ST. TAMMANY PARISH

Addendum No.: 2

Bid#: 21-16-2

Project Name: Fairground Phase 3 – Horse Stall

Below is a sample picture of the stall for example only.

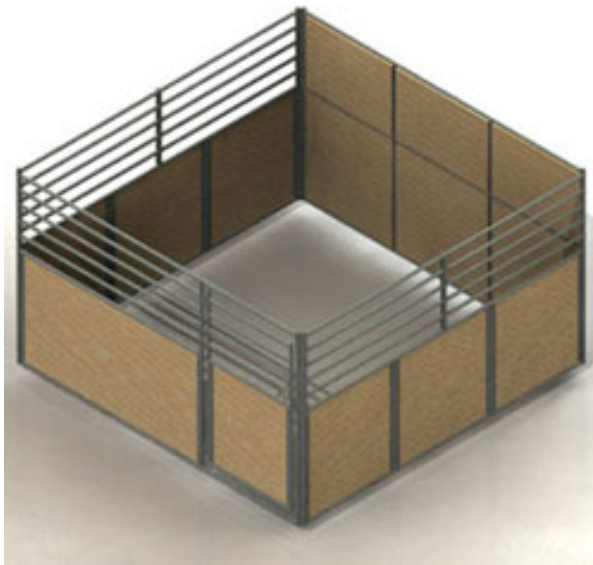
1. All panels shall be 7' to 8' tall with a horizontal vent tube to allow forklifting from the top. The bottom portion of each panel shall consist of Polyethylene panel (minimum of ¼" thick). With a minimum height of 4'. See Metal and Walls below.
2. Front and Side Panel- Top portion of each panel shall consist of horizontal metal tubing (minimum of 1.5" tubing as specified below). Spaced at a minimum of 3.5" on center. Spaced at a maximum of 5" on center.
3. Front panel consist of a gate that shall have a minimum opening of 4' wide and minimum of 6' 6" tall. The top and bottom tubing of the front panel shall be continuous from end to end.
4. Rear panel consist of a solid ¼" High Density Polyethylene panel system split into sections with horizontal vent tube on top. See wall specification below.

Metal - The horse stalls are to be made of a minimum 14 GA 1.5" round or square tubing with solid saddle welding and hot dip galvanized after fabrication. Galvanized according to the ASTM A-123 specifications.

Walls – The walls are to be constructed with ¼" High Density Polyethylene panels inserts. The poly panels are to be installed to a 2 ½" 12 GA solid flange. The HDPE poly sheet bolted in with 3/16" x 2" minimum bolt on strip sandwiching the poly sheets to the metal frame. Maximum square foot of each section can not exceed 16 square feet.

Connecting Hardware -Hardware attached to panels as sliding V bar hookups.

Hinged Doors - The doors shall be made to lay flat when opened.

Latch - Spring loaded pad lockable plunger with a striker plate welded on.

Anchoring Post – Manufacture recommended post to stabilize each cluster.
